TECHNICAL BULLETIN INDEX
Sorted by Bulletin Number
04/03/86

BULLETIN NO: II:1

PRODUCT: 26-4001/2 Model II

Figure 1

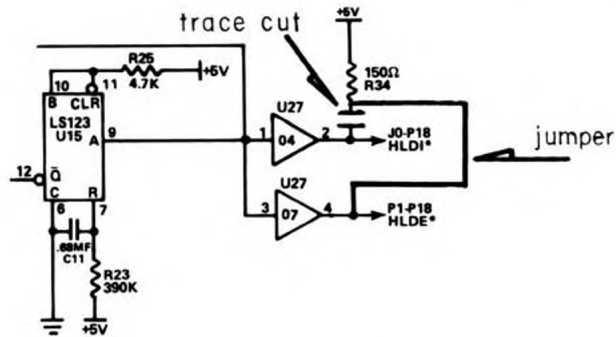
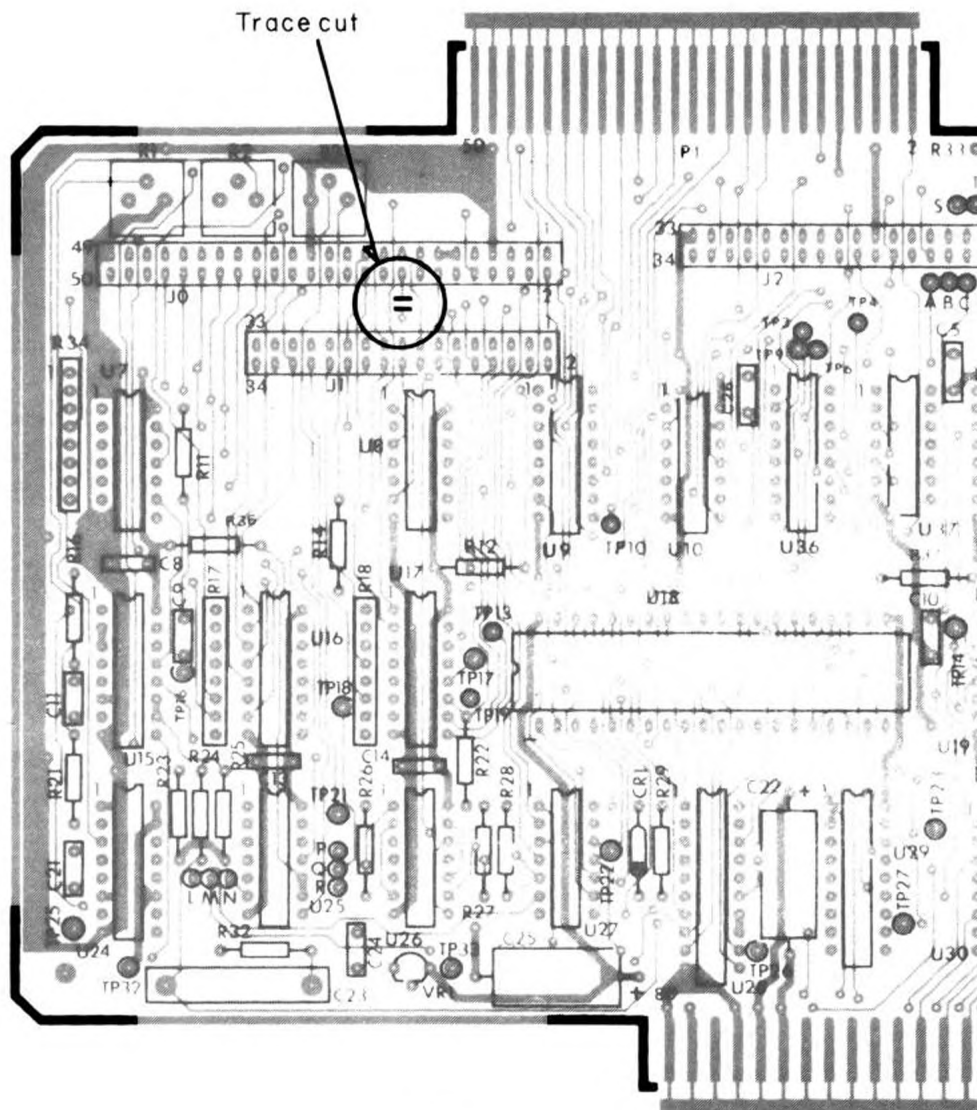
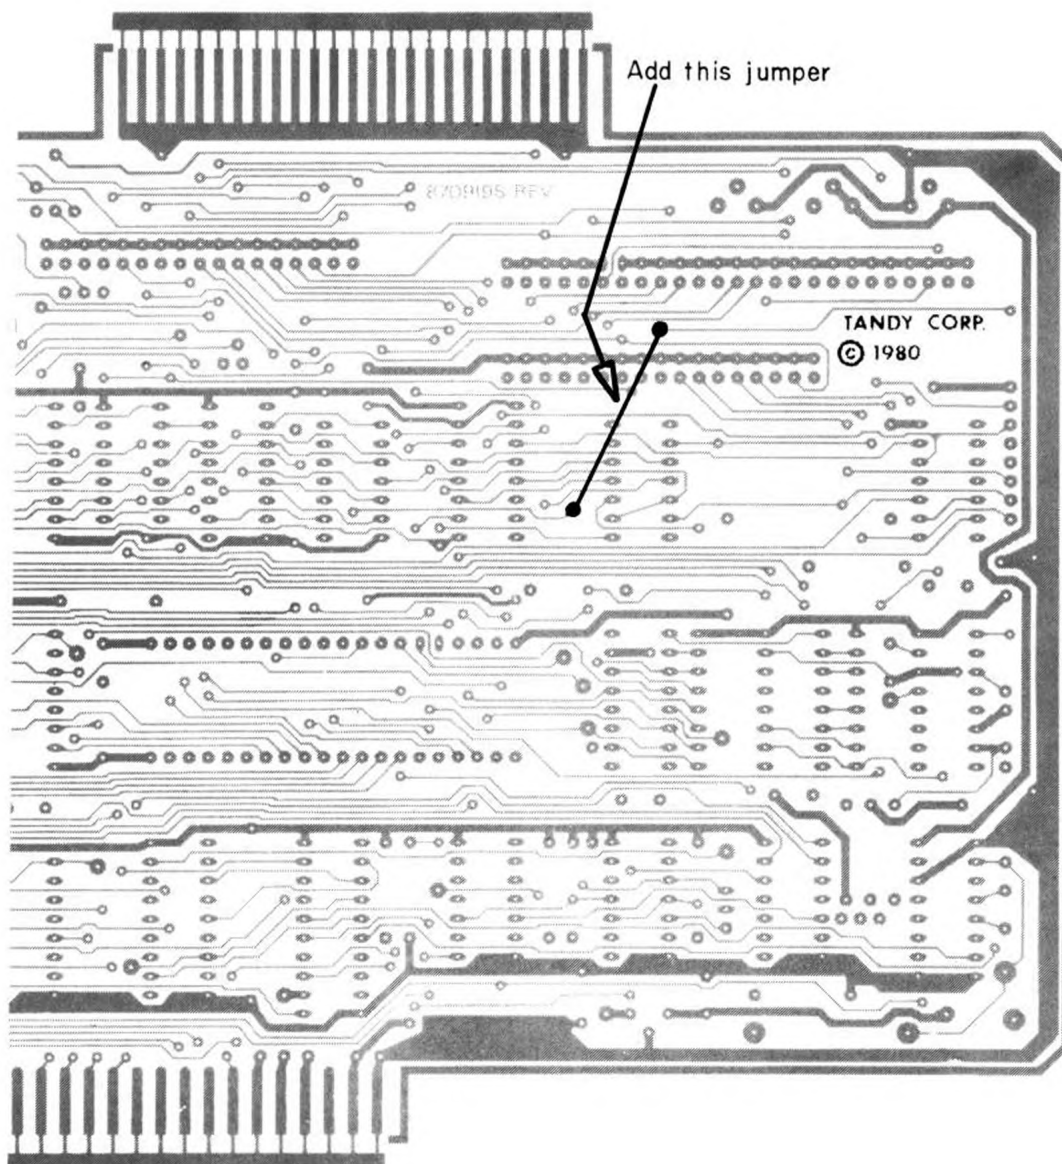
PURPOSE: To correct Head Load termination on FDC board (Late design/Rev Blank).

DISCUSSION: On the redesigned FDC board (Rev Blank) there is a pullup resistor on the Head Load signal for internal drives, but there is none for external drives. With the Model II the internal drive has Head Load termination on the board but the bay does not. With the FDC board (Redesign) this means that the internal drive has double Head Load termination while the external Head Load signal has no pullup. To correct this problem we eliminate the internal Head Load signal on the FDC board and use its pullup for the external Head Load signal (Refer to Figure 1).

1. On the componet side, cut the trace that goes to pin 18 of J0 (the 50 position pin header connector) RIGHT AT the connector so that the feedthru can still be used on the reverse side to go to the external head load signal (Refer to Figure 2).
2. Turn the board over to the solder side and solder a jumper from the feedthru referenced in step 1 (this is the pullup resistor line) to the feedthru between U8 and U9 that is closest to pin 8 and 9 of U8. This feedthru is the Head Load external signal external signal and goes over to U10 on the solder side of the board (Refer to Figure 3).

Figure 1

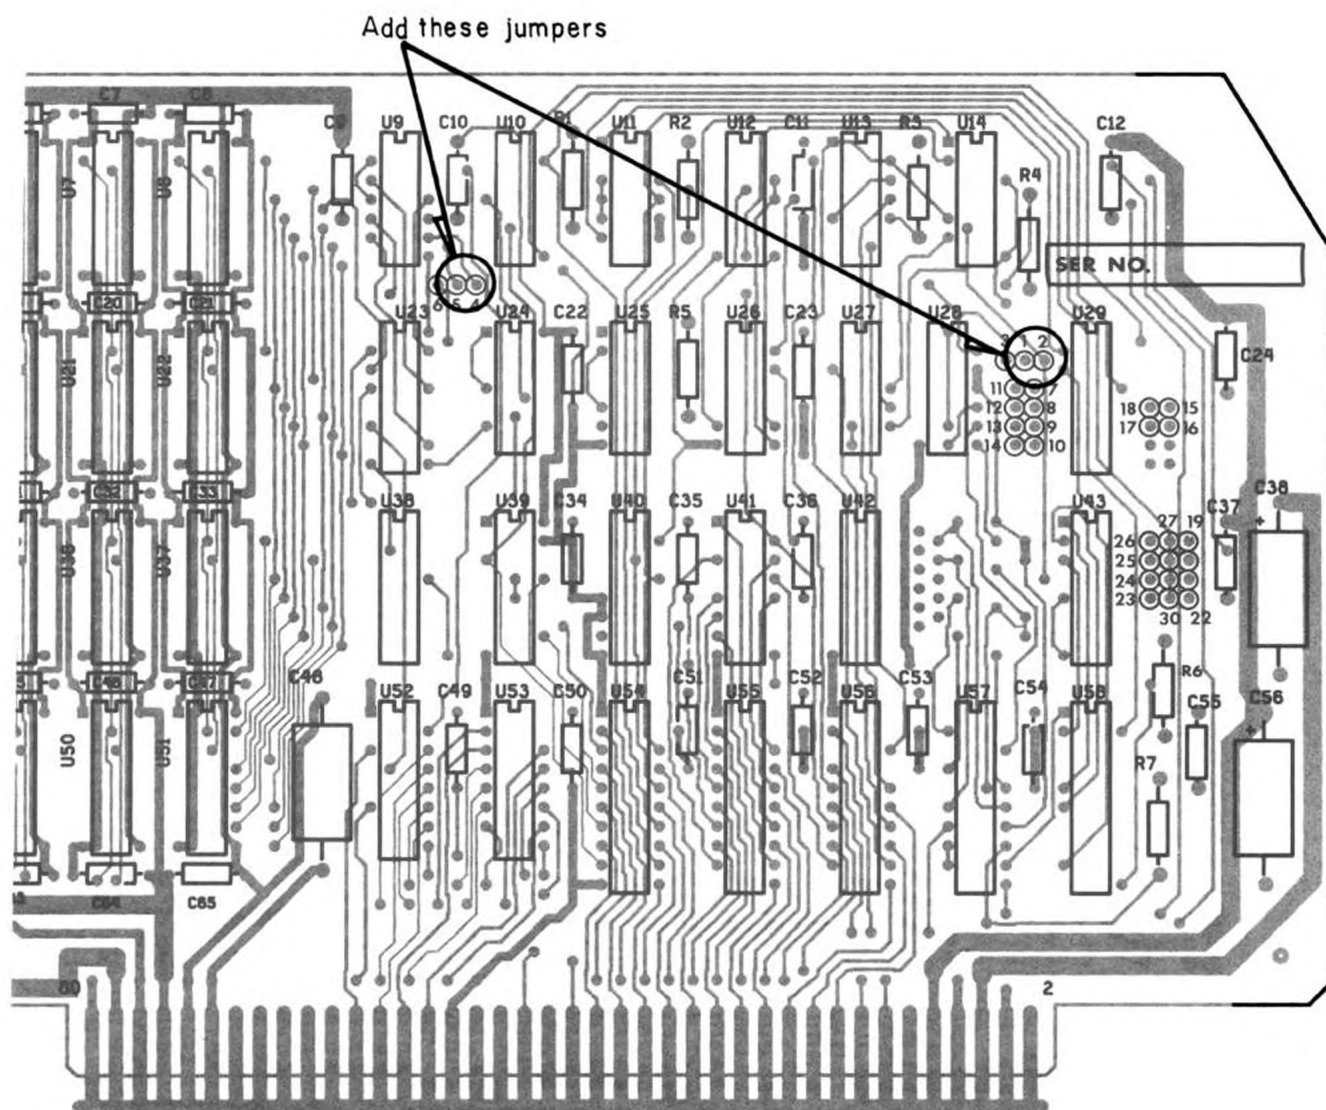
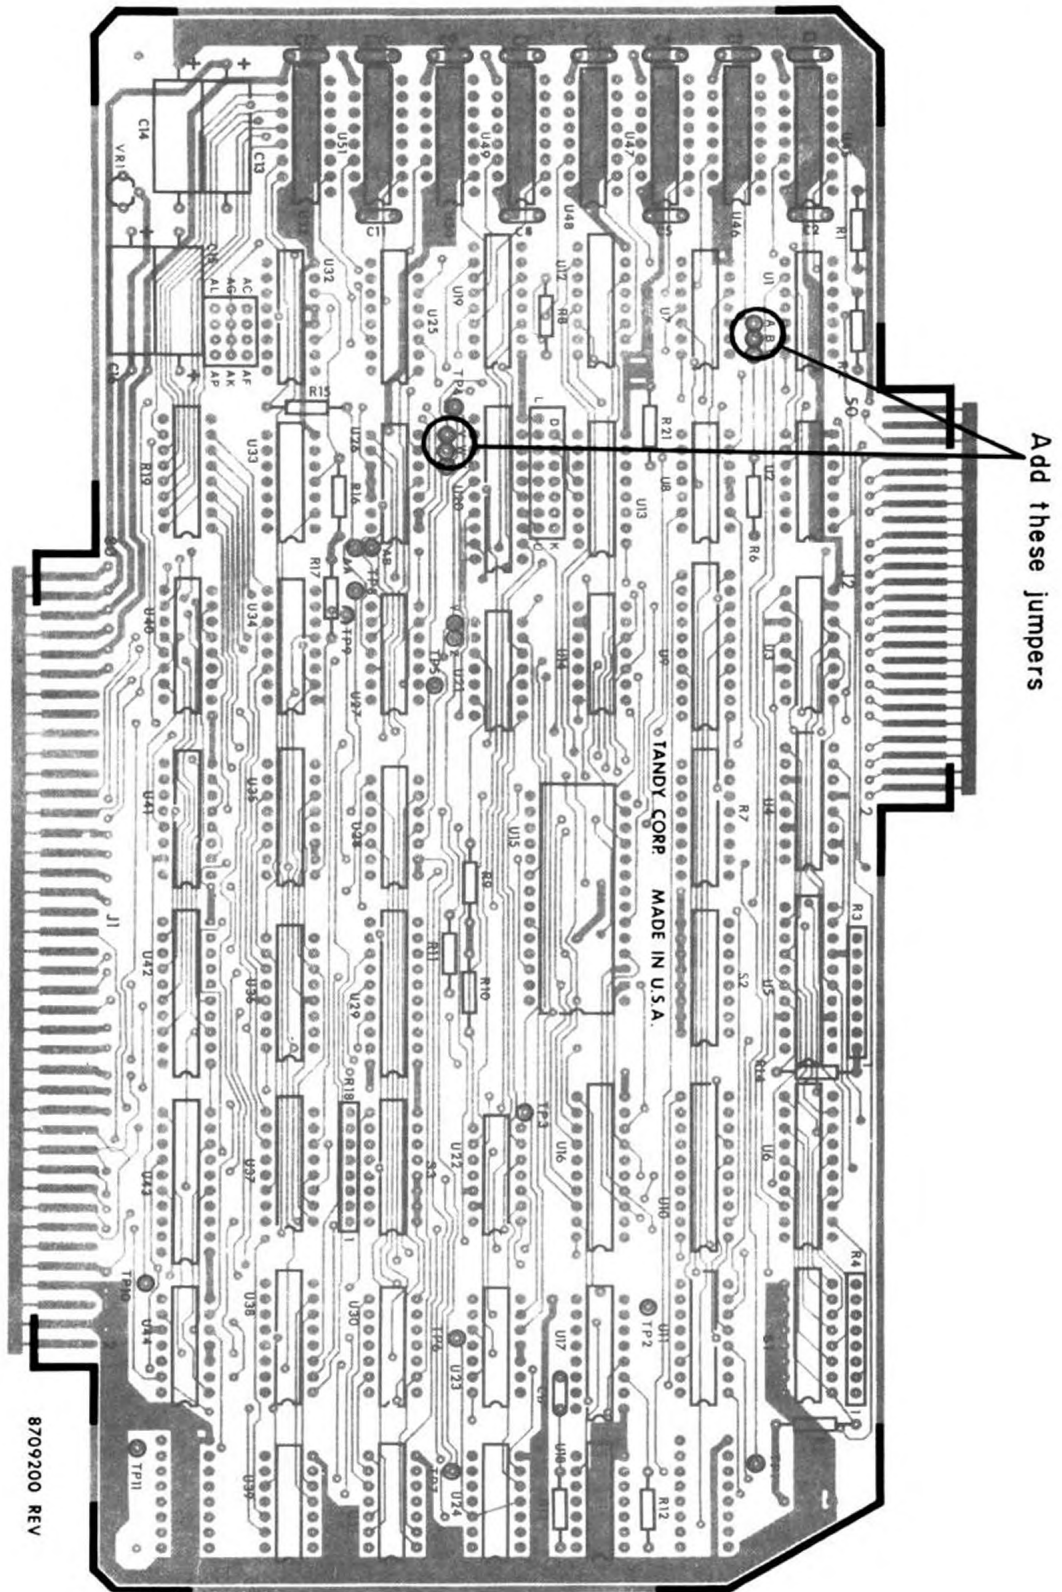
DISCUSSION: Pullups are needed on memory boards for inputs to gates. Intermittent problems can occur without these pullups installed. Some of the Model II memory boards may be missing staking pins for push on connectors and appropriate markings. In this case, use wirewrap to jumper the pads and refer to Figure 1 for pad locations.

PROCEDURE: Check boards for proper jumpering and install jumpers if they are missing. For physical locations of jumpering positions refer to Figure 1 for the memory board and Figure 2 for the Interface board.

Hard Disk Interface:
Jumper A-B and W-V

Model II Memory boards :
Jumper 1-2 and 5-6

Figure 1

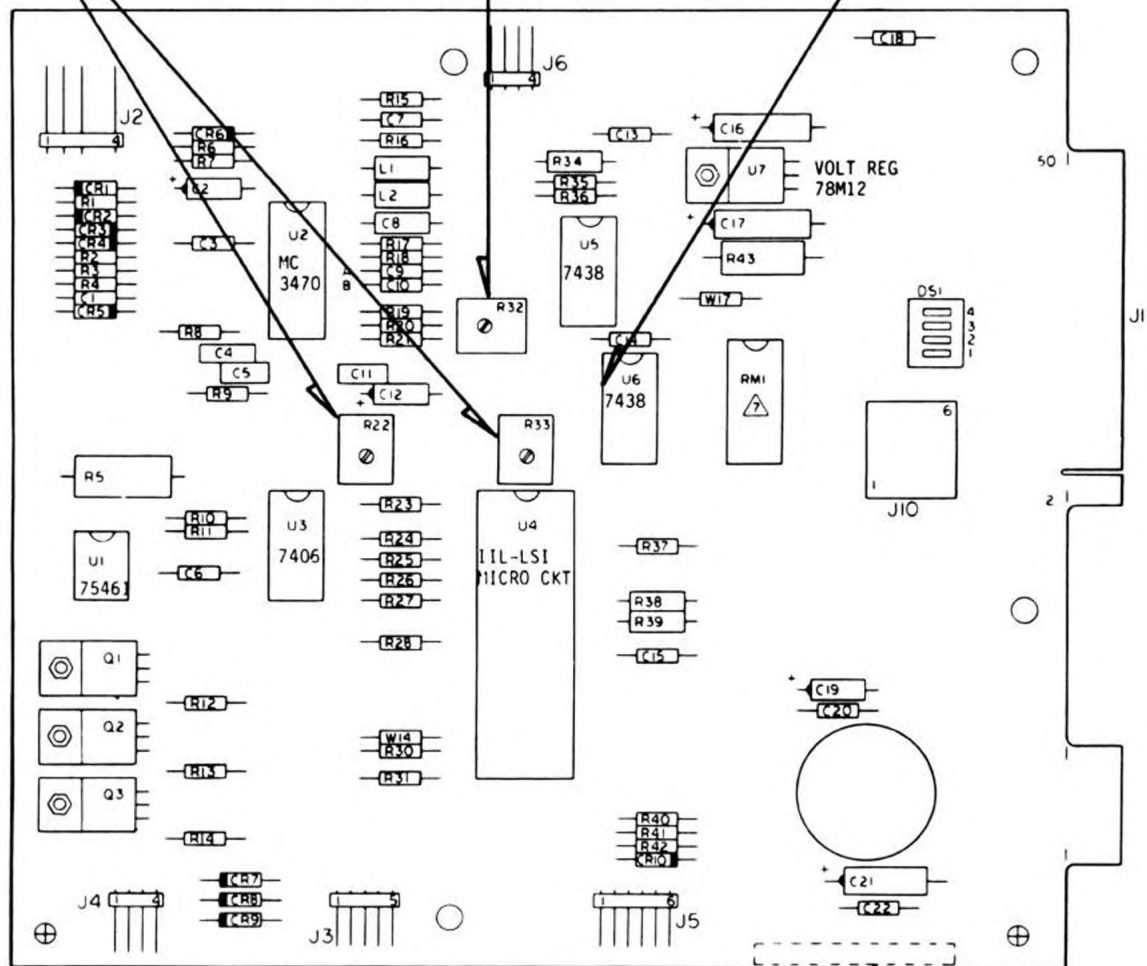
DISCUSSION: The LSI board has three adjustments R22, R23, and R32 (Refer to Figure 1). R22 and R33 are for adjusting the oscillator and write current to the head. These adjustments ARE NOT to be done in the field. The reason for this is because a test jig is needed, excessive time is required to complete the adjustments, and there is a high probability of damaging the head or the LSI chip. Once these adjustments have been done by the factory there is no reason for them to change unless the LSI chip fails. R32 controls the read symmetry (raw data) adjustment and it should be adjusted in the field.

DO NOT Adjust these

Adjust for raw data

BULLETIN NO.: II:40

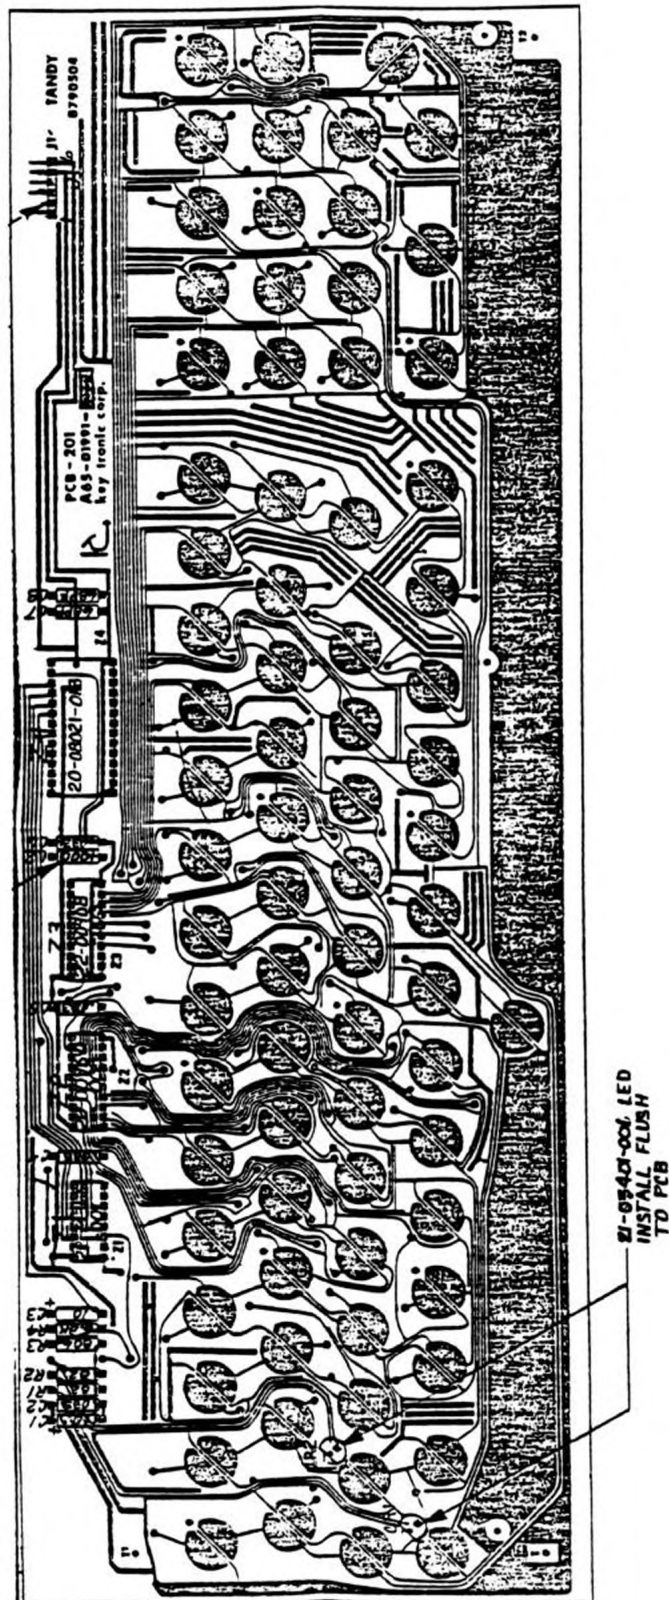
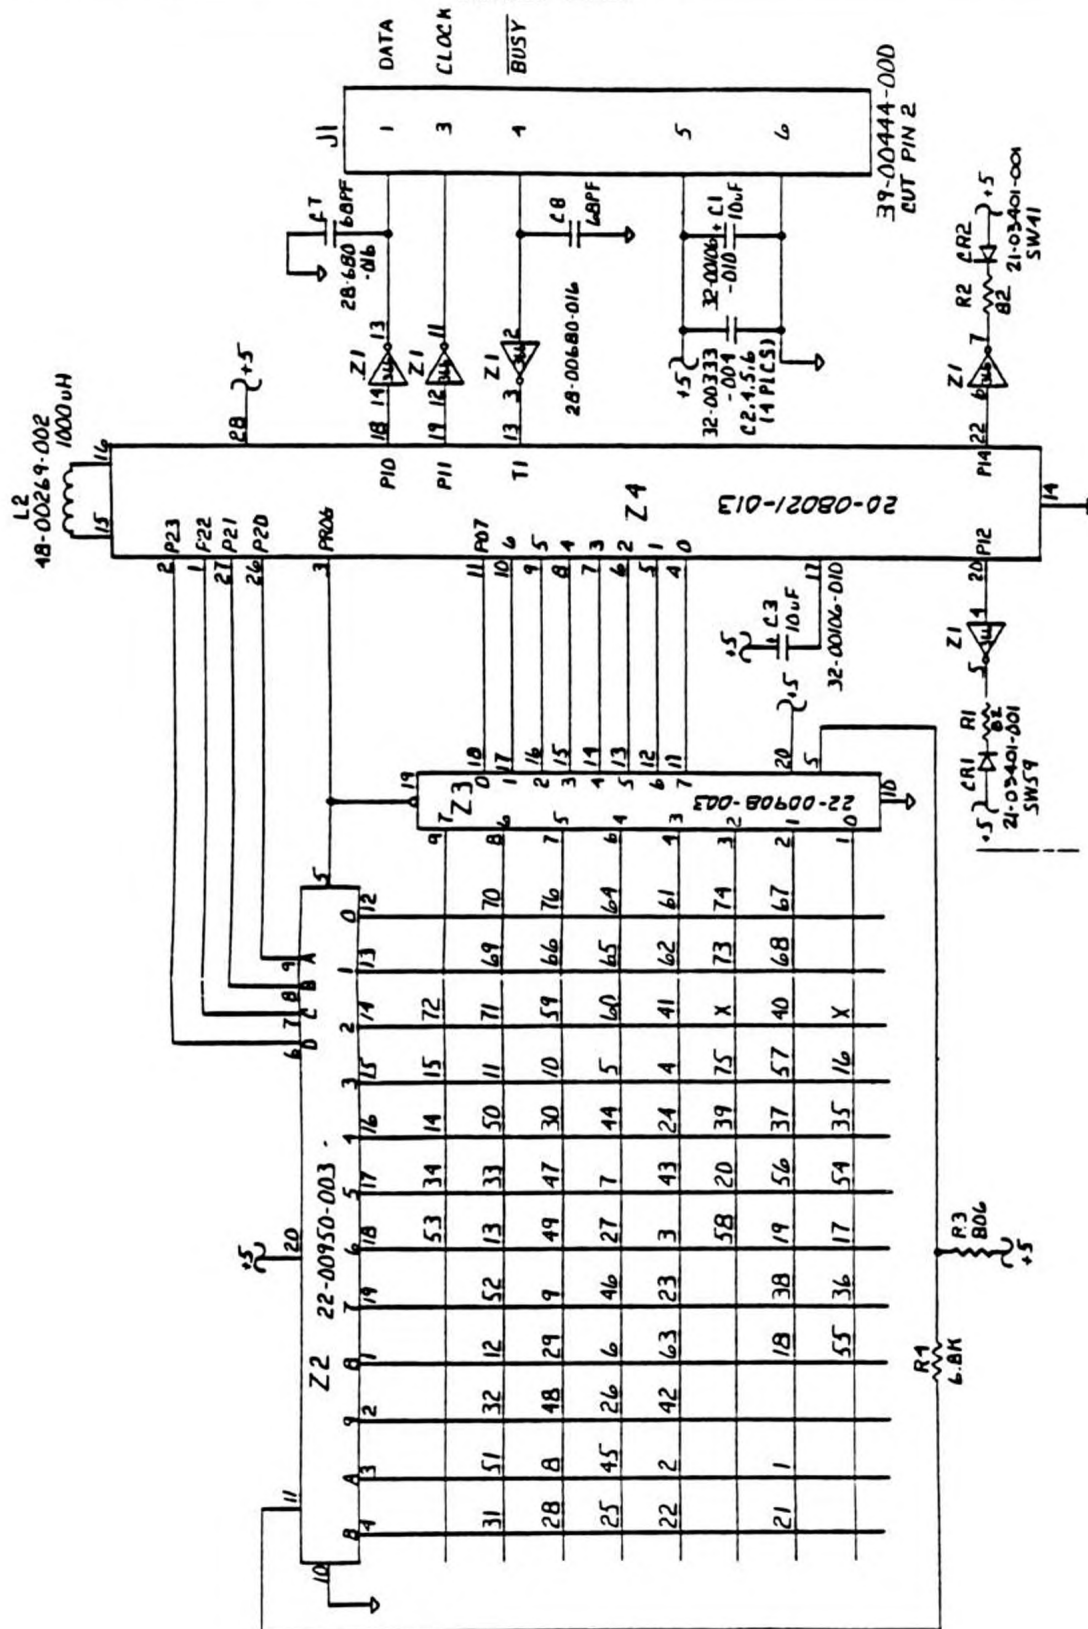
PURPOSE: Correct, and clarify the schematics on the model II/16 Key Tronic keyboards.

DISCUSSION: The Schematics for the Model II/16 keyboards in the Model II Technical Reference Manual are incorrect. Attached is the correct schematic and component location diagram.
